Subject: Upper Columbia River – Response to U.S. Environmental Protection Agency
Comments on the Draft Quality Assurance Project Plan for the Phase 2
Sediment Study

Comments and Associated Responses on the Upper Columbia River Draft Quality Assurance Project Plan for the Phase 2 Sediment Study

Conceptual site model incorporated in the draft final version of the quality assurance project plan for the Phase 2 Sediment Study. Data to be collected for exposure media and associated ecological receptors have been highlighted for this Phase 2 sediment study.

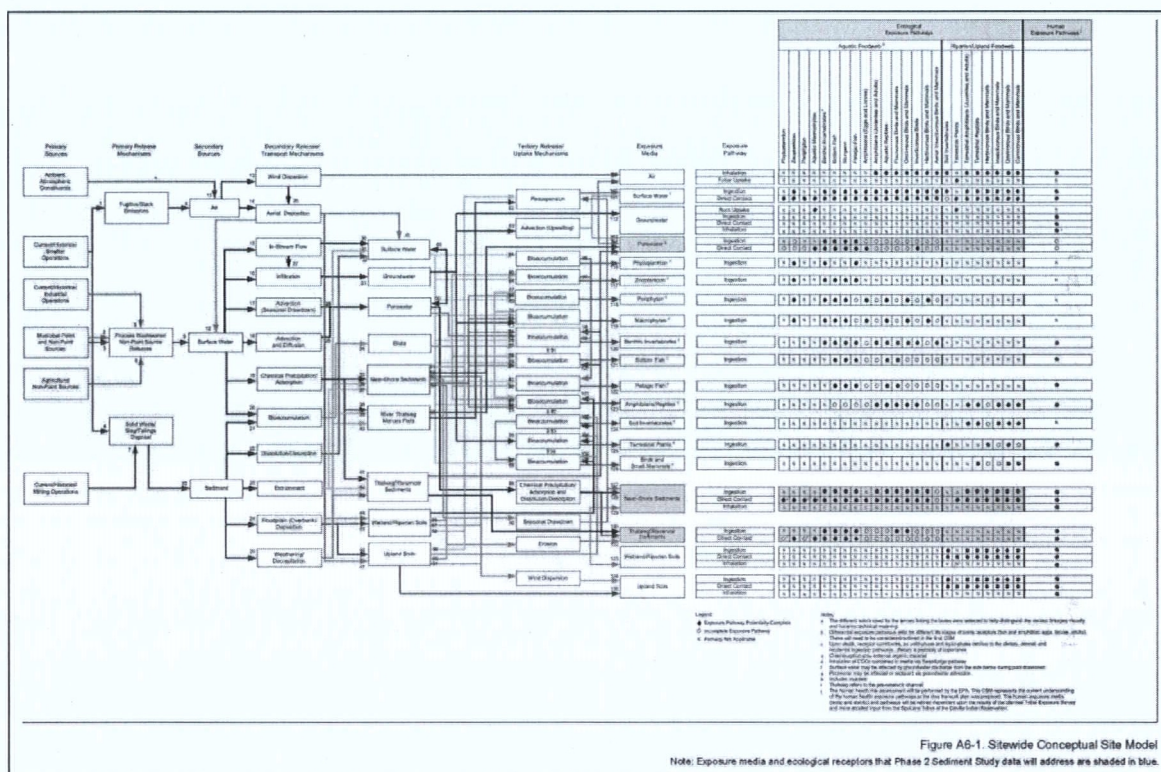
1) **DQOs** – The revised sediment QAPP must expand section A7.2 to include a more comprehensive description of the Data Quality Objectives and the testable risk questions the study will address. The section must explain how this QAPP fits into the BERA workplan and the Problem Formulation Plan. It must also make clear which receptors/pathways are covered by the proposed investigations by referring to the CSM. For example, the draft QAPP is narrowly focused on the assessment of risk to benthic organisms, but the resulting sediment data may also be used in the evaluation of risk to aquatic plants, sediment-probing birds, and other receptors. Additional DQOs are indicated in several of the following general comments including:

Section A6 - The following text has been added to this section: “In addition, sediment and porewater data collected during this study can and will be used to inform other components of the BERA. For example, these data can and will be used, as appropriate and applicable, in the evaluation of unacceptable risks to other ecological receptors such as aquatic plants and sediment-probing birds, see Figure A6-1.” A copy of Figure A6-1 referenced herein is provided below.

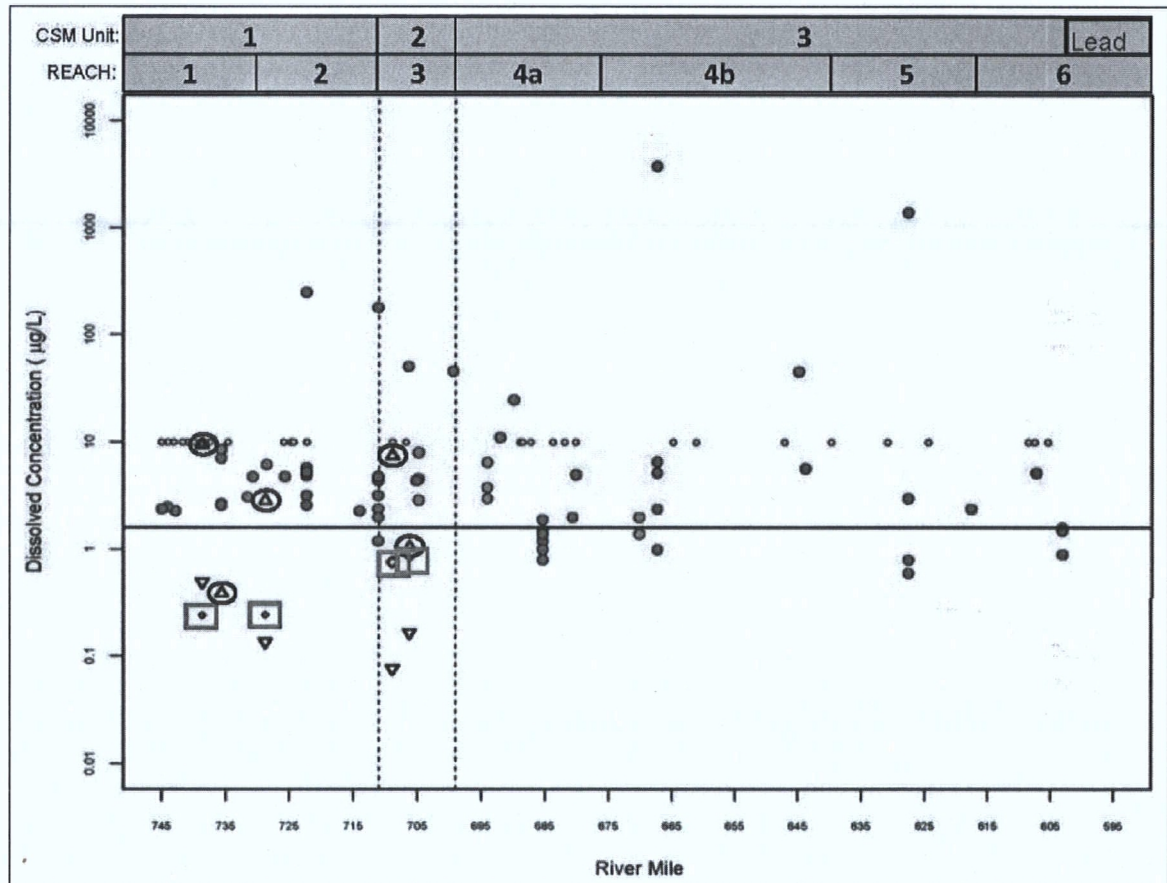
- 5) **Pore Water Sampling:** DQOs describing the goals of field collected pore water and lab pore water collections must be included in a revised QAPP. The EPA is willing to consider pore water data collected using the air stone method proposed in the draft QAPP. However, this is a non-standard method and it has shown some potential for bias over other methods

(i.e., concentrations of lead were lower than from peepers, DGTs, and known concentrations in spiked water; White Sturgeon Methods Development Data Summary and Evaluation [Teck 2010]). Therefore, concentration-response relationships in laboratory exposures will be assessed using pore water collected from peepers in chemistry-only bioassay test beakers for each sediment sample. Analytes not determined from peepers in laboratory bioassays will be measured in pore water extracted via centrifuge from splits of homogenized sediments prepared for bioassays. The revised QAPP must describe in more detail how Teck intends to collect field porewater from sample locations requiring multiple sediment grabs, how Teck intends to compare field-collected and laboratory derived porewater, and how the field collected porewater could inform the risk assessment.

We appreciate the U.S. Environmental Protection Agency’s willingness to consider porewater data collected using the ceramic airstone and wish to confirm that the draft final quality assurance project plan clearly identifies that peepers (see Section B4.2.1) will be used to collect laboratory-porewater for dissolved metal analyses. To maintain consistency between field- and laboratory-based porewater measurements and reduce uncertainties in the aforementioned field/laboratory ‘translation’ factor, it is important that the airstone also be used to extract laboratory-based porewater for analytes not determined from peepers. As detailed within the draft final quality assurance project plan, porewater collected via the

airstone within the laboratory will be analyzed for water quality parameters essential to assess and interpret metal bioavailability. Since the aforementioned methods development work, validated analytical data are publically available as collected during the “Assessment of Sediment Toxicity to White Sturgeon (*Acipenser transmontanus*)” study. Based on this data set, in which over 200 porewater measurements were made using the airstone, the aforementioned bias in dissolved lead concentrations does not appear to be present. Rather and as illustrated within the figures below, dissolved porewater concentrations recorded using the airstone appear consistent with other high-quality data studies conducted within the upper Columbia River.

Plot of Dissolved Lead Porewater Concentrations within the upper Columbia River as a Function of River Mile. This base plot appears in Appendix B, Attachment B3 of the quality assurance project plan (excluding the 2010 white sturgeon data) and as requested by the U.S. Environmental Protection Agency will be updated following the Phase 2 Sediment Study. In addition to including data from the Phase 2 Sediment Study, porewater data collected as part of the remedial investigation/feasibility study (e.g., the 2010 white sturgeon sediment toxicity assessment as above) will also be included. Average porewater concentrations collected during the 2010 white sturgeon sediment toxicity assessment have been included above to illustrate the effectiveness of ceramic airstones. Dissolved lead concentrations recorded during the 2010 white sturgeon sediment toxicity assessment from airstones and peepers appear as triangles (highlighted with a blue oval) and diamonds (highlighted with a pink square), respectively. Note that average dissolved lead concentrations extracted using the ceramic airstones are consistent with other site data.
